CITY OF ALBUQUERQUE

RE: 323 Jefferson Apartments 323 Jefferson SE Grading Plan Stamp Date: 7/23/19 Hydrology File: K17D116

GRADING & DRAINAGE PLAN

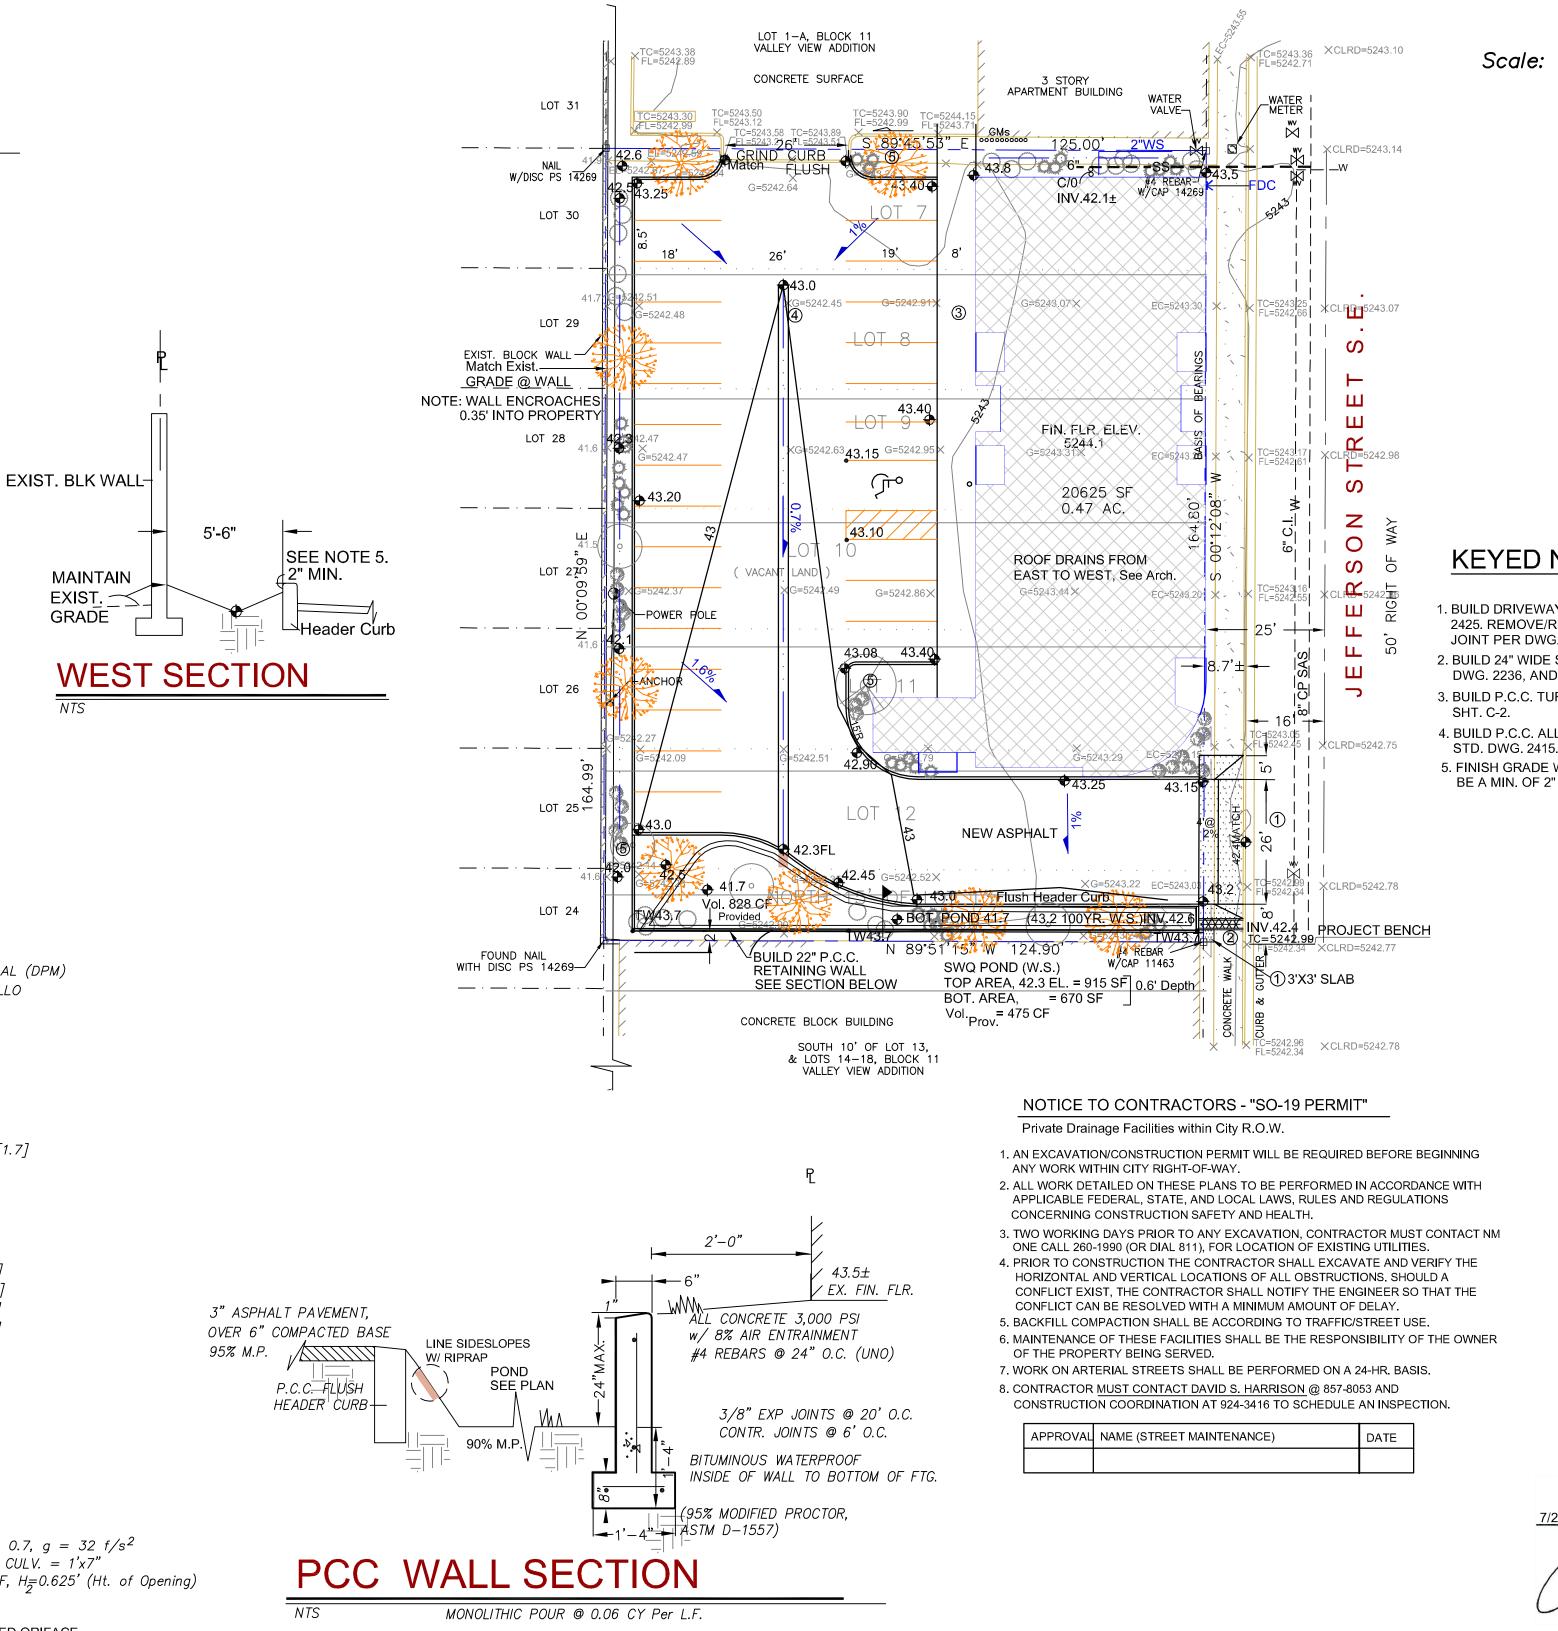
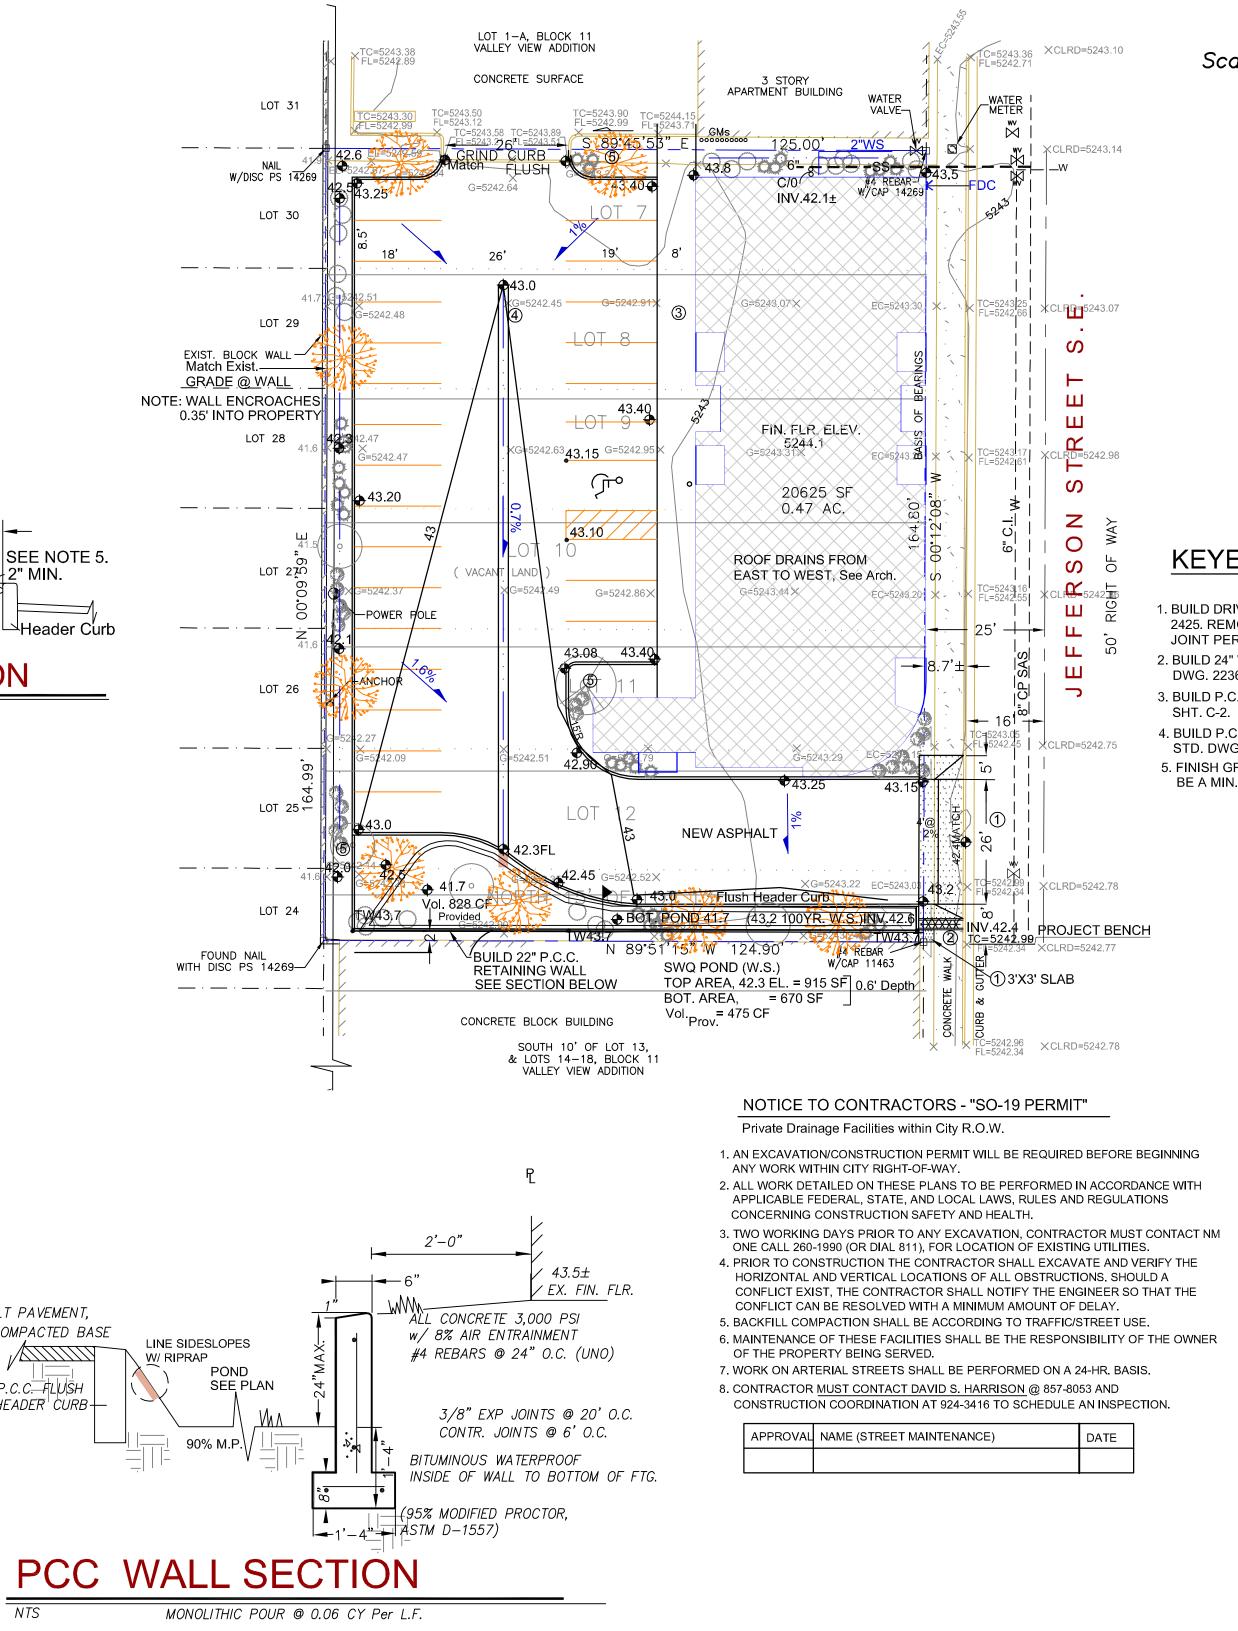
PO Box 1293Based on the submittal received on 7/29/19 the above-referenced Grading Plan is approved for
Building Permit and SO-19.Prior to Certificate of Occupancy (For Information):Albuquerque1. Engineer's Certification, per the DPM Chapter 22.7: Engineer's Certification Checklist For
Non-Subdivision is required.NM 871032. The sidewalk culverts must be inspected and approved by Storm Drain Maintenance (Augie
Armijo at (505) 857-8607).

A Bernalillo County Recorded <u>Drainage Covenant (No Public Easement)</u> is required for the stormwater control pond. The original notarized form, exhibit A (legible on 8.5x11 paper), and recording fee (\$25, payable to Bernalillo County) must be turned into DRC (4th, Plaza del Sol) for routing. Please contact Charlotte LaBadie (clabadie@cabq.gov, 924-3996) regarding the routing and recording process for covenants. The routing and recording process for covenants can take a month or longer; Hydrology recommends beginning this process as soon as possible as to not delay approval for certificate of occupancy.
